Rezoning Transportation Analysis

Petition Number: 2018-024

General Location Identifier: 17518221, 17518222, 17518223

Revision Log:

Outstanding Issues

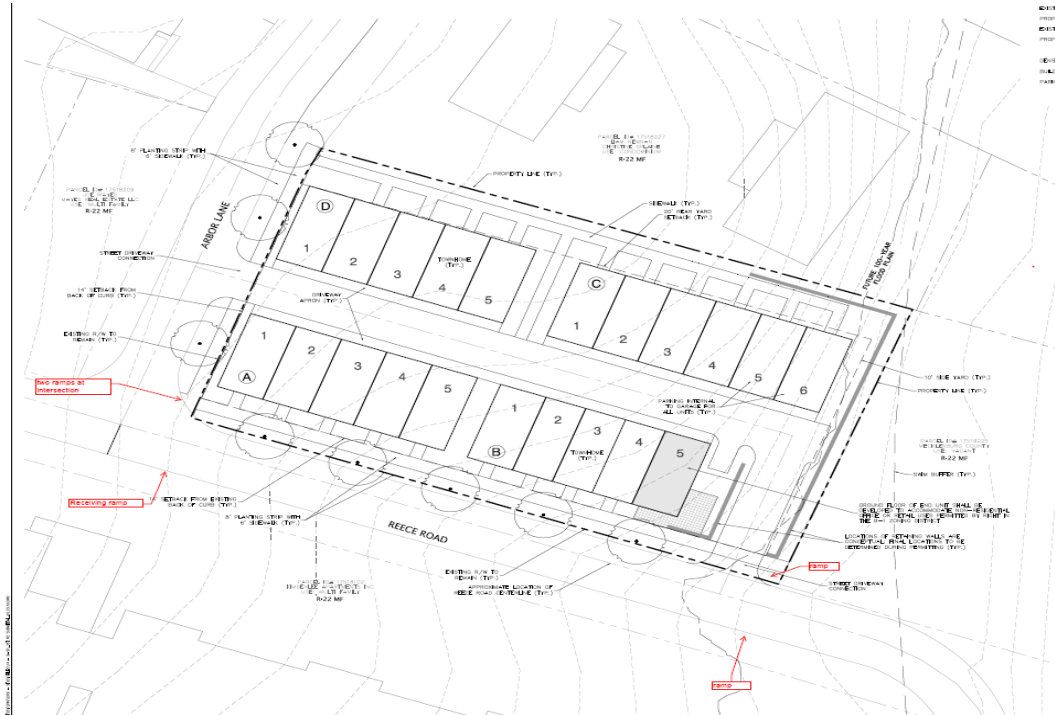
1. **Curbline** The proposed zoning district has a setback measured from back of the existing or proposed future curbline. The location of the future back of curb is the existing back of curb.
2. **Traffic Study** A Traffic Impact Study/Transportation Technical Memorandum is not necessary for the complete review of this petition.
3. The petitioner should revise the site plan and conditional note(s) to show ADA ramps at the intersection of Reece Road and Arbor Lane, Receiving ramp across Reece Road at intersection of Reece and Arbor, ramp east of driveway on Reece, and receiving ramp across from requested ramp on Reece.

4. The petitioner should revise the site plan to add a note specifying dedication and fee simple conveyance of all rights of way to the City before the site's first building certificate of occupancy is issued. CDOT requests right of way set at 2' behind back of sidewalk where feasible.
5. The petitioner should revise the site plan to add a note specifying all transportation improvements will be approved and constructed before the site's first building certificate of occupancy is issued. The petitioner may phase transportation improvements if said improvements and phasing are explicitly described in site plan notes.
6. New Comment: CDOT has concerns about the proposed most northern tree on Arbor Lane conflicting with how sidewalk will need to tie back to existing sidewalk.
